HISTORIC AND DESIGN REVIEW COMMISSION

HDRC CASE NO: 2022-130
ADDRESS: 334 W ELSMERE PLACE
LEGAL DESCRIPTION: NCB 3967 BLK 2 LOT E 25 FT OF 3 & W 25FT OF 4
ZONING: R-5,H
CITY COUNCIL DIST.: 1
DISTRICT: Monte Vista Historic District
APPLICANT: Tom Krulevitch
OWNER: Peter & Susana Krulevitch
TYPE OF WORK: Exterior modifications, construction of a rear addition, rear accessory structure modifications and addition, site modifications
APPLICATION RECEIVED: February 10, 2022
60-DAY REVIEW: Not applicable due to City Council Emergency Orders
CASE MANAGER: Stephanie Phillips

The applicant is requesting conceptual approval to:

ADU ELEVS PROPOSED
1/4" = 1'-0"

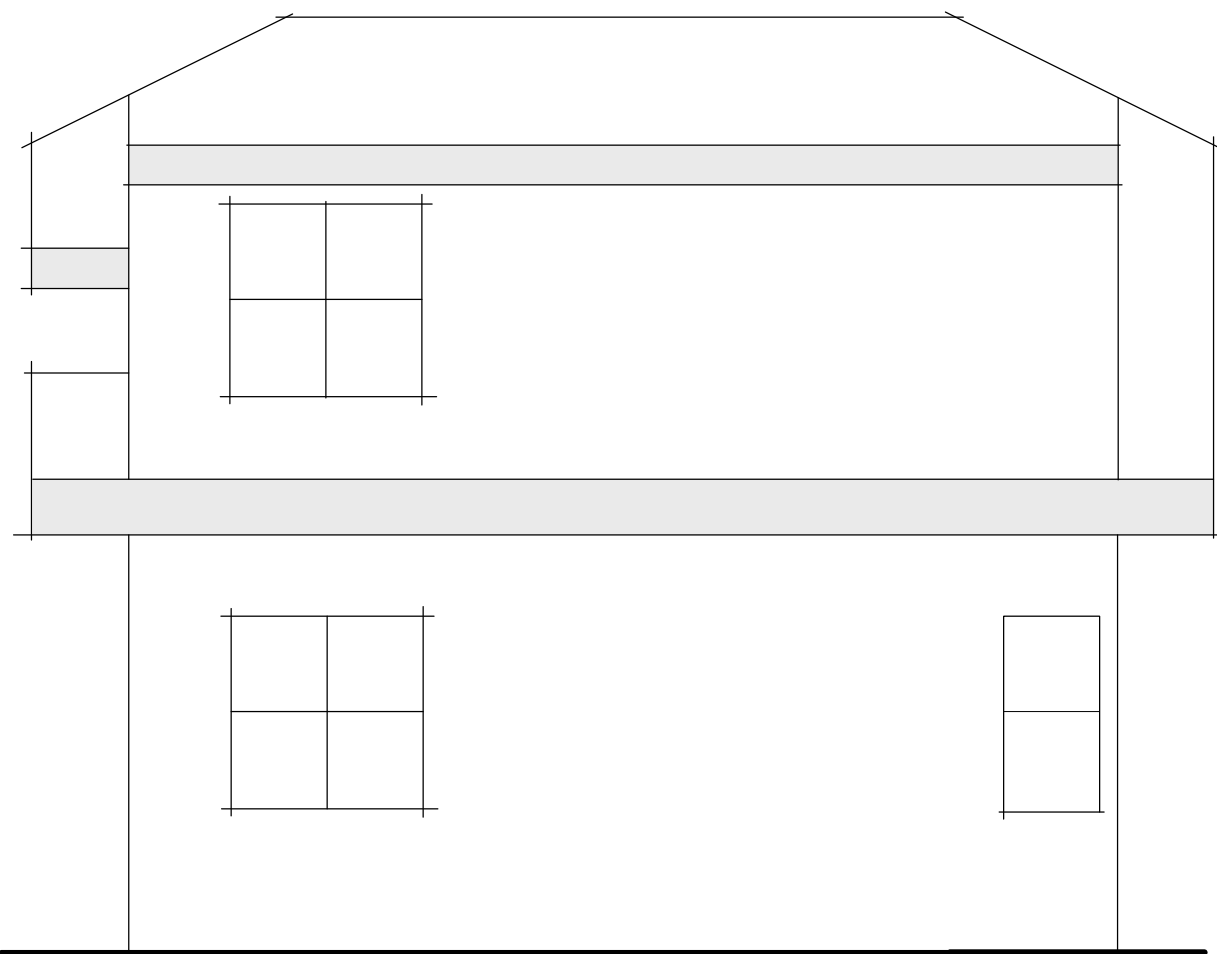
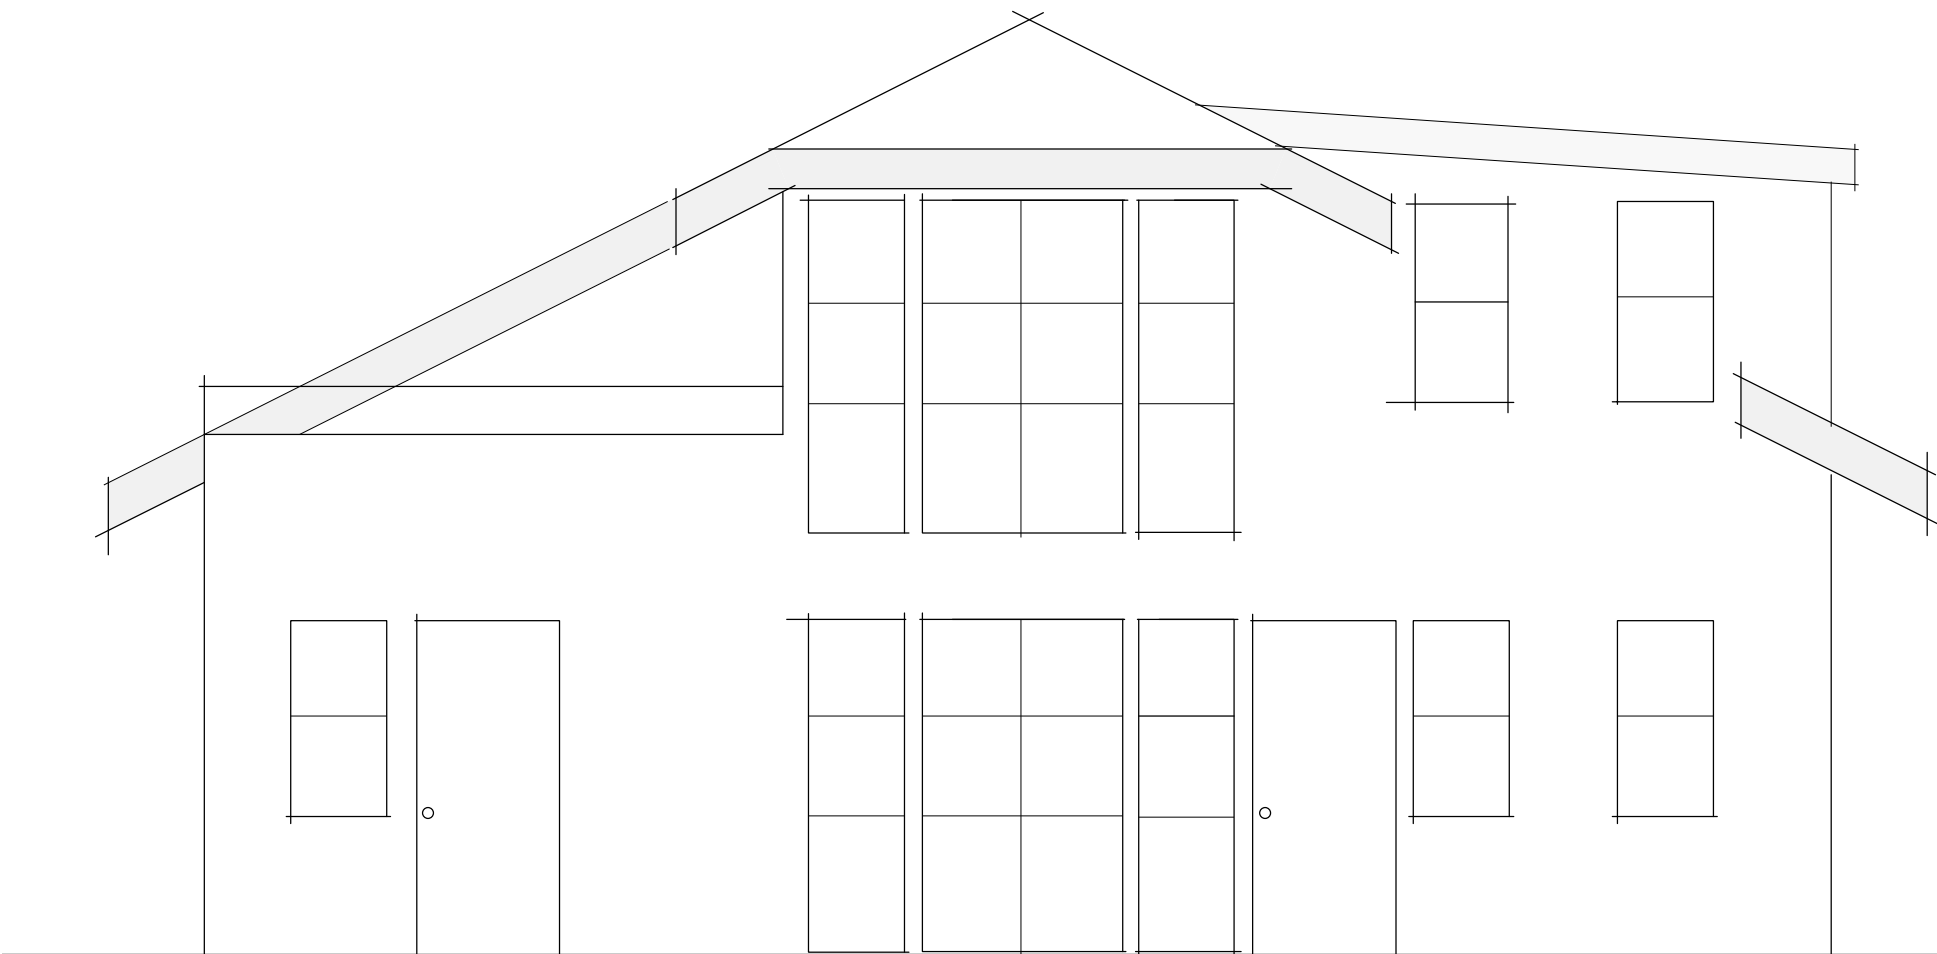
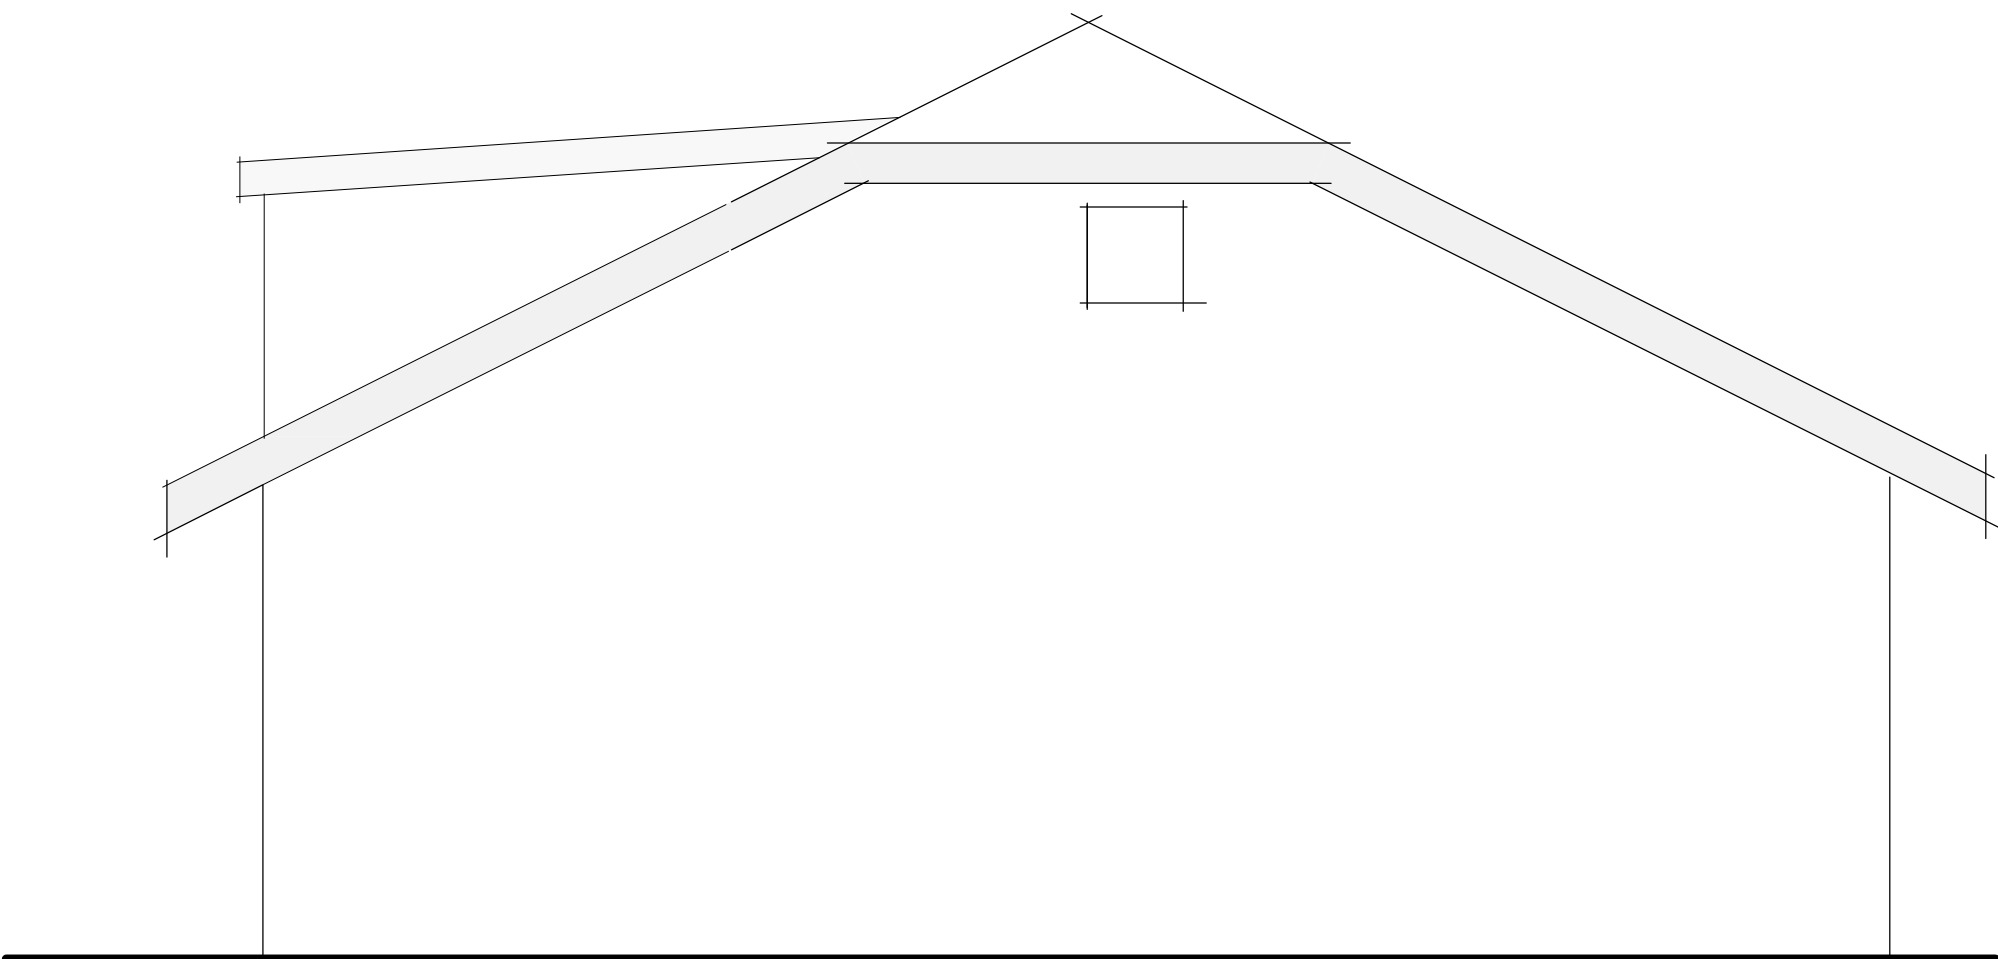
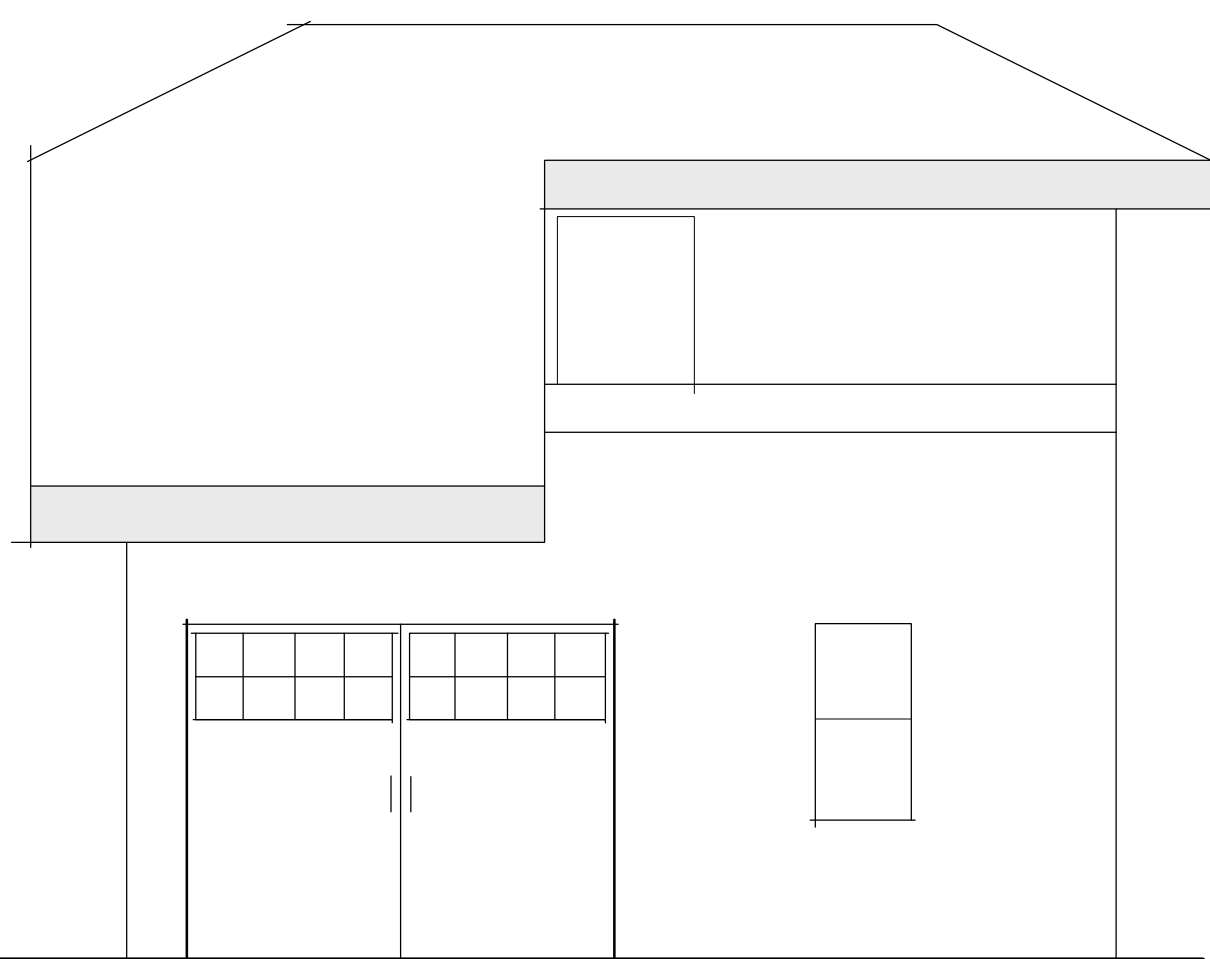
- j. **REAR ACCESSORY STRUCTURE MODIFICATIONS** – Per the submitted documents, two walls of the existing rear garage will be removed, resulting in new footprint to support a second story addition and additional exterior modifications. The two remaining walls will be retained and incorporated into the new design, which features a taller primary roofline, a new fenestration pattern, and new exterior garage doors facing the street. At this time, staff does not find the proposal conceptually appropriate due to limited visual clarity, unclear drawing convention, and an incomplete understanding of exactly what materials will be retained from the existing garage. Staff finds that applicant should aim to maximize material salvage from the walls to be removed for reuse in the new design and submit a clear salvage and reuse plan, in addition to measured, dimensioned drawings. Staff also finds that the applicant should propose modifications that are consistent with the Guidelines for Additions pertaining to roof forms, fenestration patterns, massing, scale, and materials.

- v. That the applicant submits a rear accessory structure proposal that includes clear elevations and additional information on which materials will be retained in the new design as noted in finding j. The drawings should also indicate the height of the rear structure relative to the primary structure.

- vi. That the applicant incorporates roof forms, materials, and fenestration patterns into the rear accessory structure modifications that are consistent with the Guidelines as noted in finding j.

[E] MAIN VIEWS & AB/D

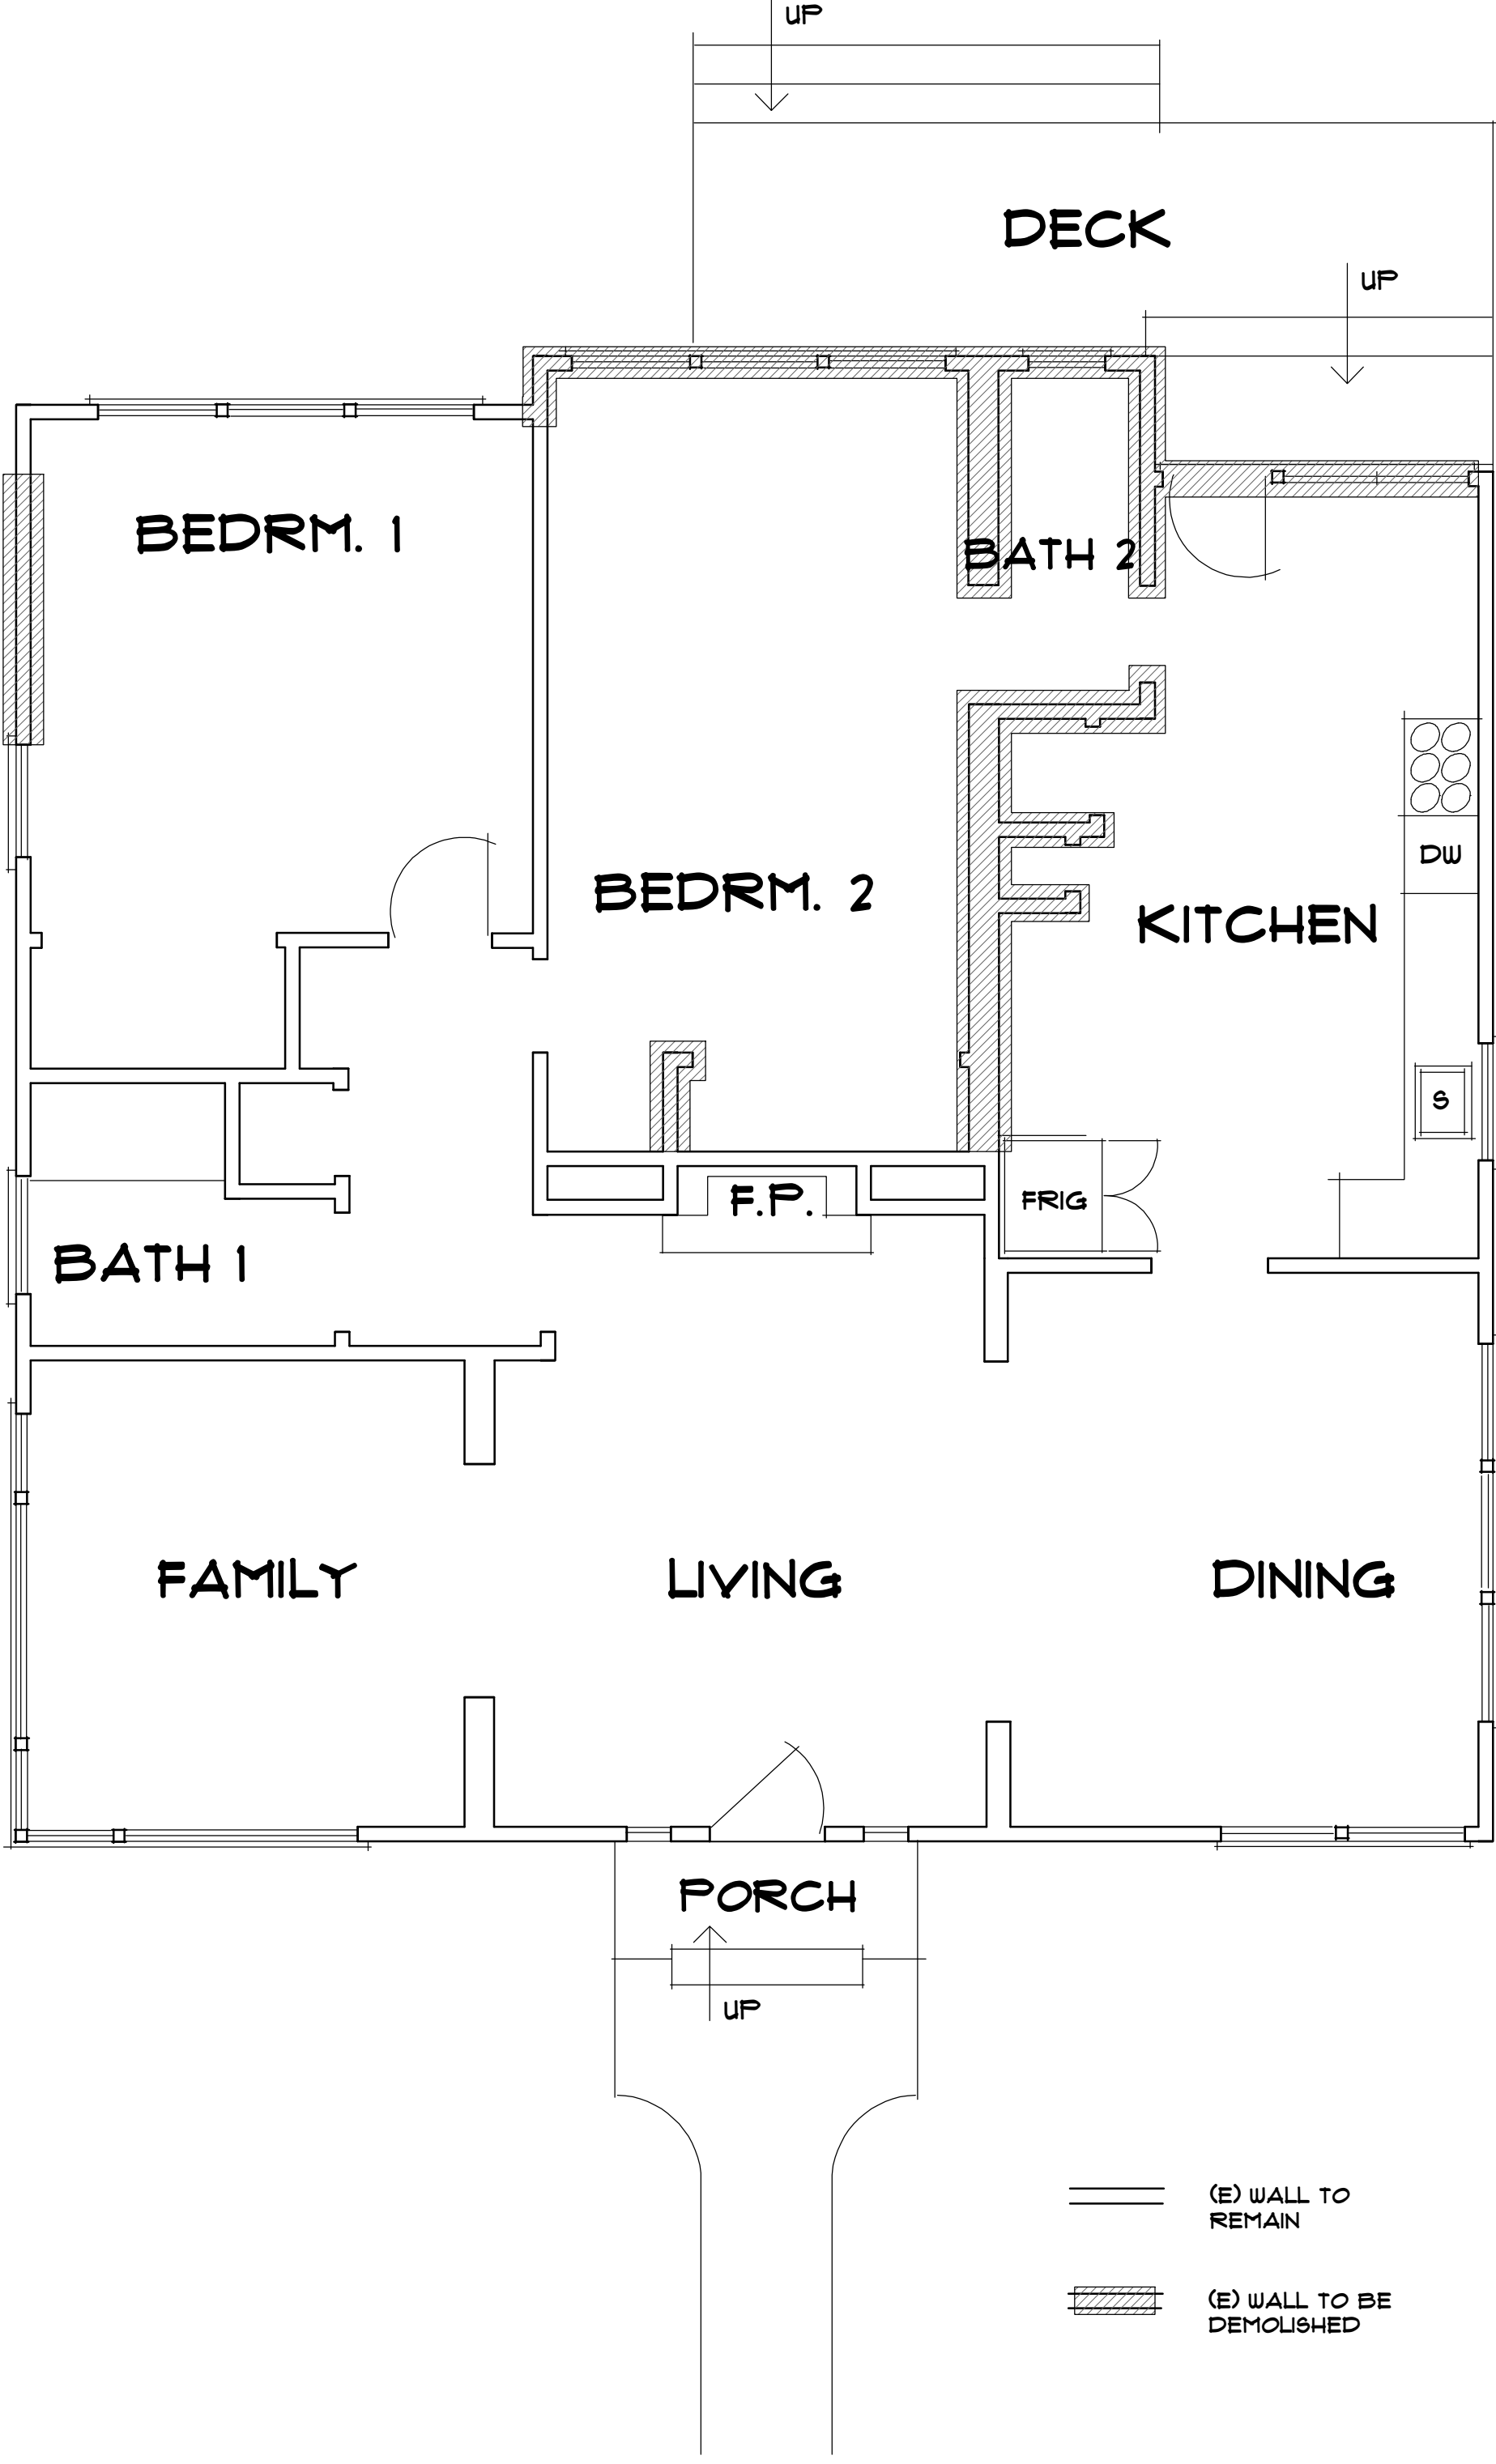
- d. ADDITION: MODIFICATIONS TO EXISTING STRUCTURE – The applicant has proposed to construct a 1-story rear addition to the existing 1-story historic house, which will require exterior modifications to the existing structure. Based on submitted photographs and the conceptual documents, the proposed modifications appear to include the removal of an existing window and door configuration on the rear elevation. Staff finds that the removal of elements of the rear addition are acceptable for the new addition and recommends that any salvageable elements be reutilized in the new addition.

- iii. That the applicant salvage and reuse the windows to be removed for the rear addition as noted in findings d and h.
- iv. That the applicant explores adding fenestration to the right and left elevations of the addition for final approval as noted in finding h.
